Atmel AVR539: Migrating from AT90PWM216/316 to AT90PWM81/161

Application Note

This application note is a guide to help current Atmel[®] AT90PWM216/316 users convert existing designs to Atmel AT90PWM81/161.

Table 21-1. Digital Input Disable Register 0/1 – DIDR0/1 versus AT90PWM216/316 and AT90PWM81/161.

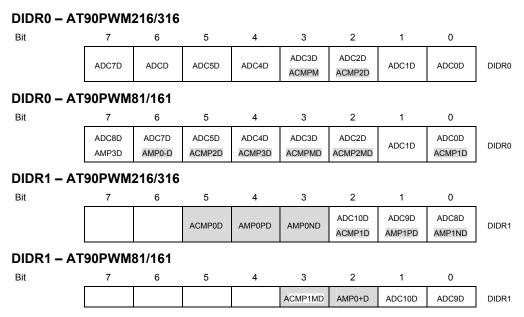
The bits locations in DIDR0 and DIDR1 have been changed between the two products. See the following tables.
